MIL-PRF-19500/757C
w/AMENDMENT 3
3 October 2025
SUPERSEDING
MIL-PRF-19500/757C
w/AMENDMENT 2
25 February 2021

PERFORMANCE SPECIFICATION SHEET

TRANSISTOR, FIELD EFFECT RADIATION HARDENED,
P-CHANNEL, SILICON, THROUGH HOLE AND SURFACE MOUNT, TYPES 2N7624 AND 2N7625
QUALITY LEVELS JANTXV AND JANS

FIGURE 1. Dimensions and configuration, TO-257AA (T3).

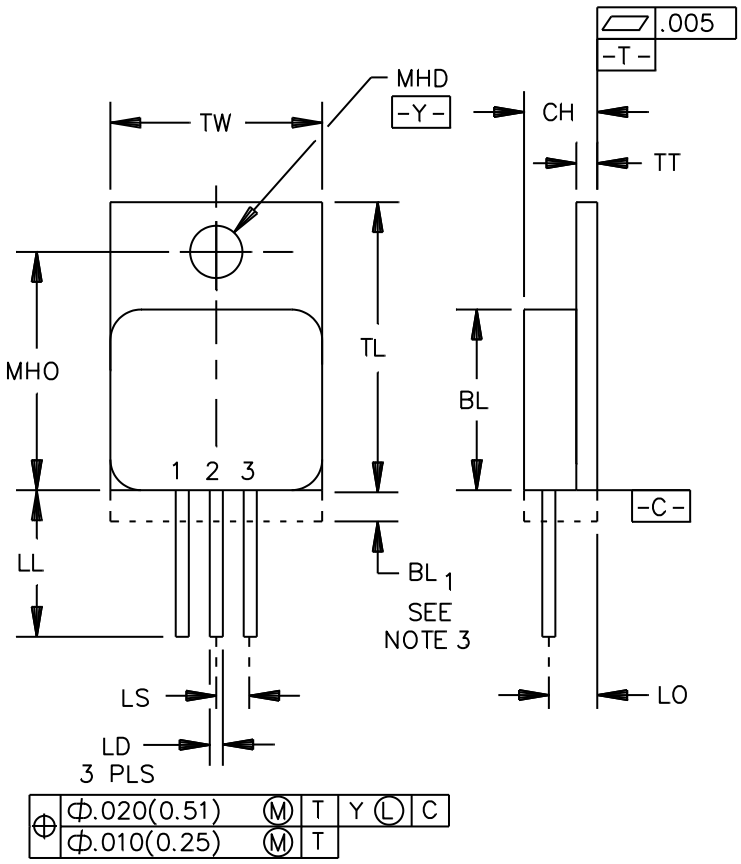
* NOTES:
1. Dimensions are in inches. Millimeters are given for general information only.
2. All terminals are isolated from the case.
3. This area is for the lead feed-thru eyelets (configuration is optional, but will not extend beyond this zone).

FIGURE 2. Dimensions and configuration TO-276AA, SMD-0.5 (U3).

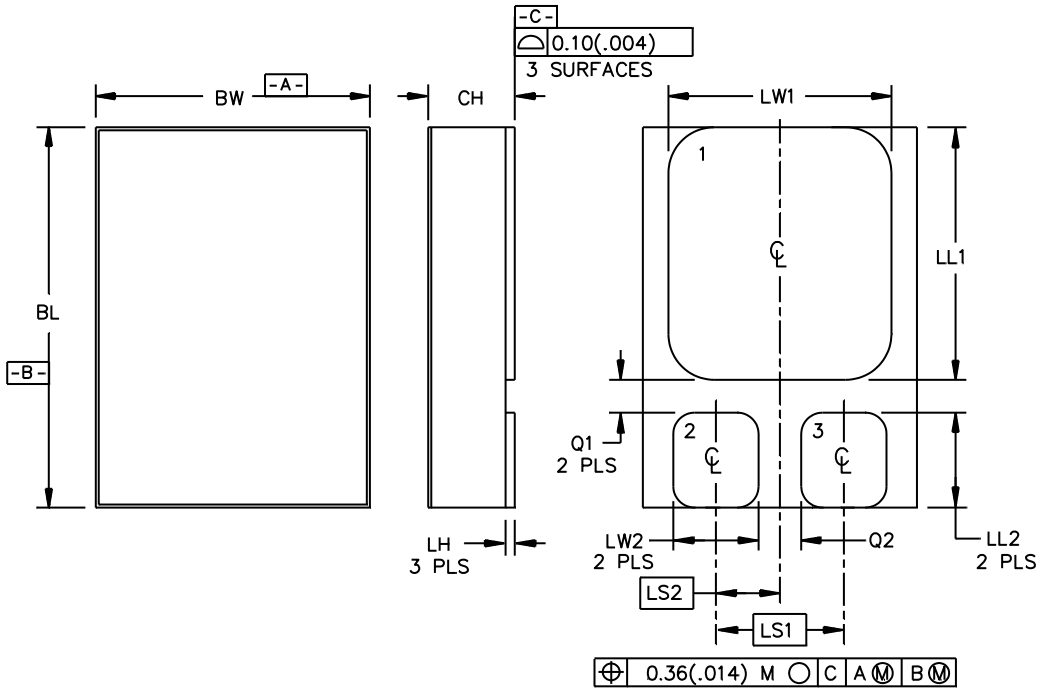
* NOTES:
1. Dimension are in inches.
2. Millimeters are given for information only.
3. The lid shall be electrically isolated from the drain, gate and source.

FIGURE 3. Dimensions and configuration (Similar to TO-276AA, SMD-0.5), with ceramic lid U3CE.

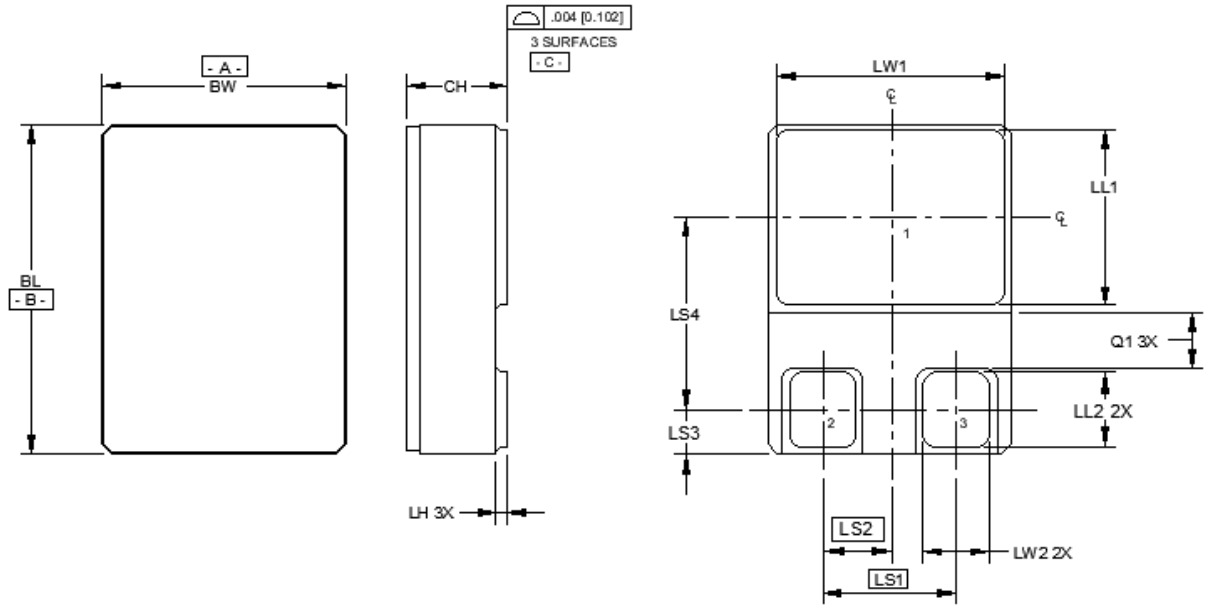
* NOTES:

1. Dimension are in inches, Millimeters are given for information only.
2. Dimension tolerances ±.005.
3. The lid shall be electrically isolated from the drain, gate, and source.
4. Dimensions are pre solder finish
